RE: Agenda Item 25-263, PD-20 Zone Change from Commercial Office to Business Park
 and Medium High Density Residential

TENTATIVE MAP

YOSEMITE AVE SUBDIVISION

GRADING PLAN

SHEET #
C4.0

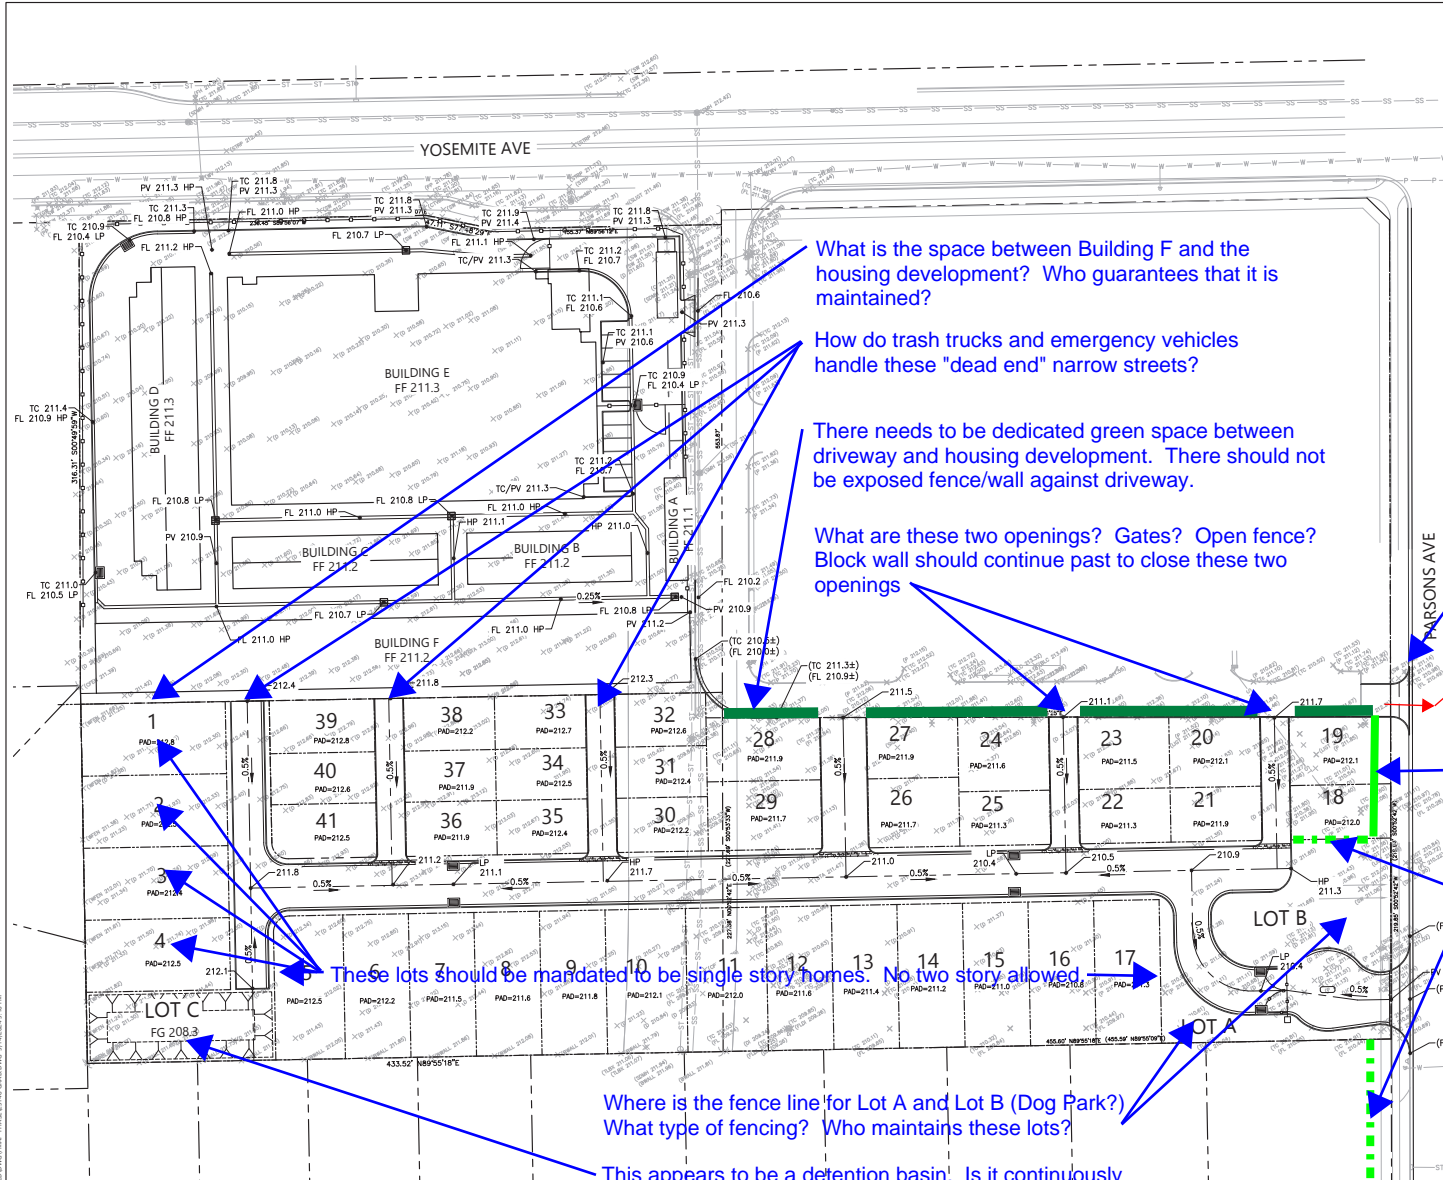
What is the space between Building F and the housing development? Who guarantees that it is maintained?

How do trash trucks and emergency vehicles handle these "dead end" narrow streets?

There needs to be dedicated green space between driveway and housing development. There should not be exposed fence/wall against driveway.

What are these two openings? Gates? Open fence? Block wall should continue past to close these two openings

New driveway has unsafe northbound exit on to Parsons. Too close to the Yosemite intersection

Subdivision wall setback with landscaping along Parsons should match Oakmont

This should be a block wall to match Oakmont wall.

These lots should be mandated to be single story homes. No two story allowed

Where is the fence line for Lot A and Lot B (Dog Park?) What type of fencing? Who maintains these lots?

This appears to be a detention basin! Is it continuously maintained lawn and landscape or weeds mowed once a year?
